Certificate of Appropriateness

Property 1921 N. 2ND ST. Brewers Hill HD

Description of work Construct new two car garage at alley, at over 100' from the front lot line per the attached drawings with the following alterations to that which is stated on the drawings. Garage is to be constructed with cementitious fiber plank siding with smooth finish (Hardieboard or similar). Trim shall be clear grain cedar wood or similar rot-resistant species. Pitch on roof shall be increased to 10/12.

Date issued 5/17/2018 PTS ID 114482 COA: new garage

1 FRONT (WEST) ELEVATION

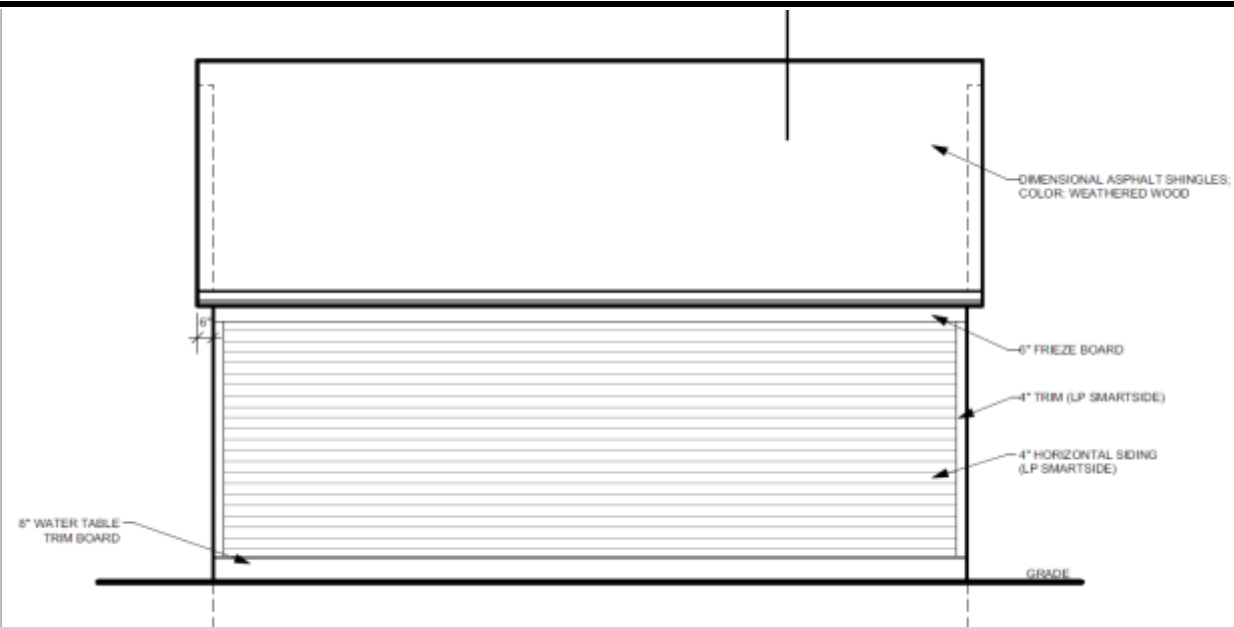
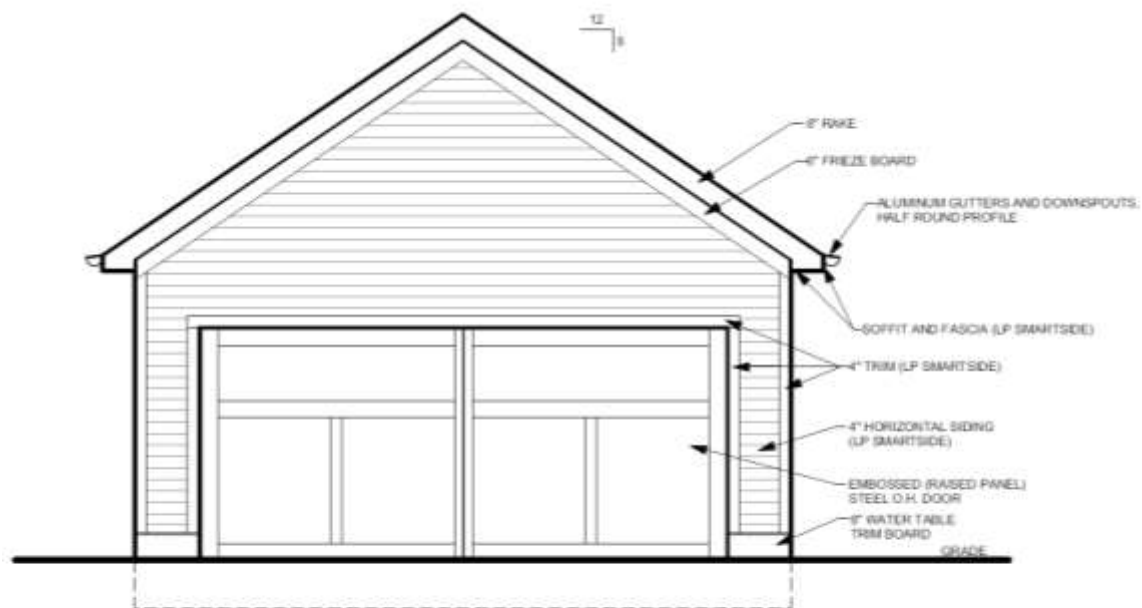
Disregard materials and roof pitch stated here, see first page.

1 FRONT (WEST) ELEVATION

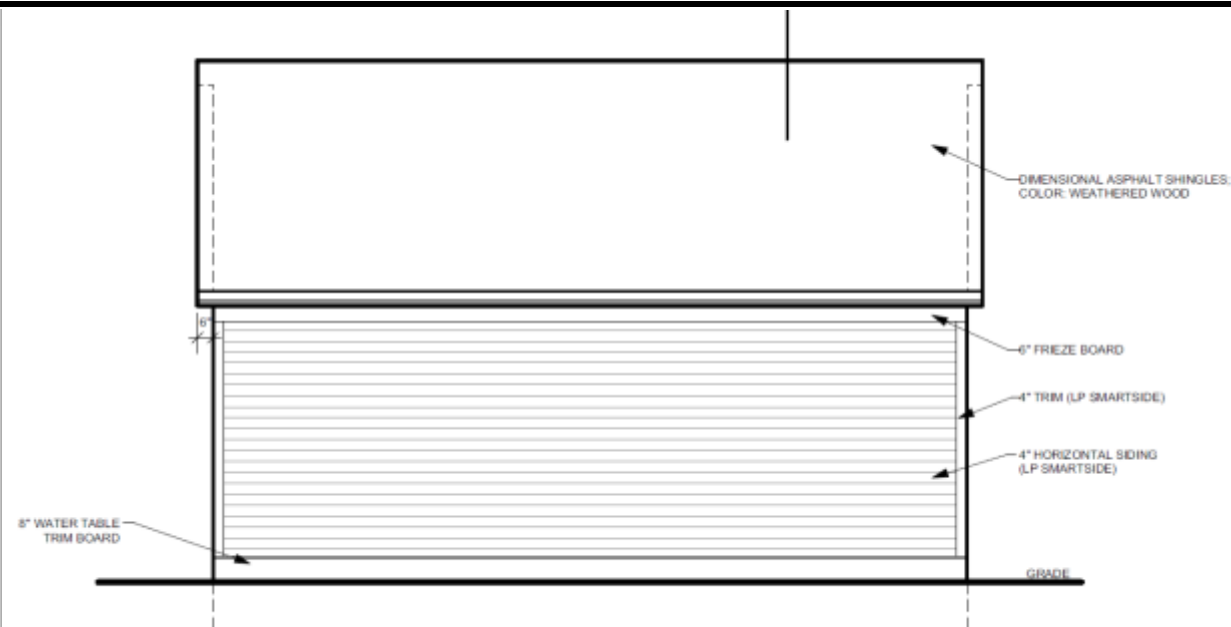
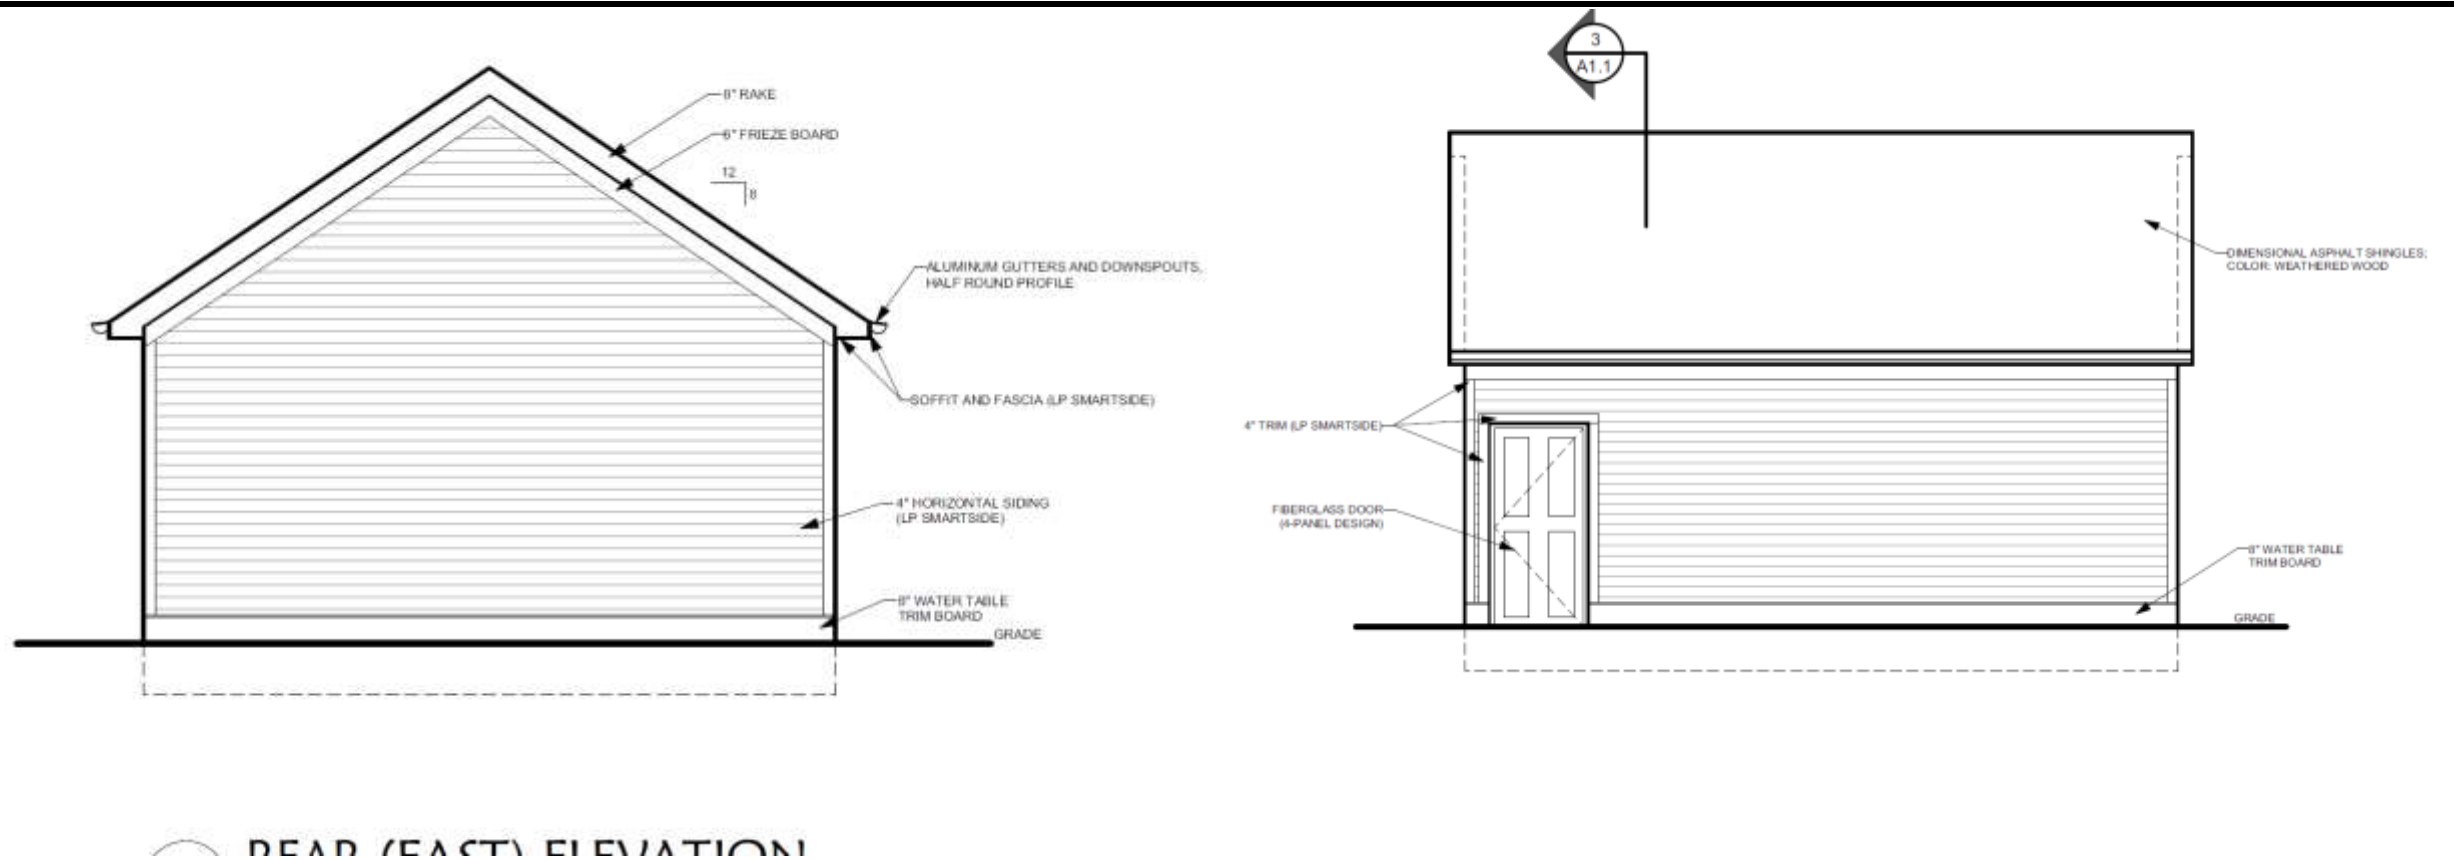
Disregard materials and roof pitch stated here, see first page.
Siding shall be hardiboard (or similar) with cedar trim and roof pitch shall be 10/12

Disregard materials and roof pitch stated here, see first page.
Siding shall be hardiboard (or similar) with cedar trim and roof pitch shall be 10/12
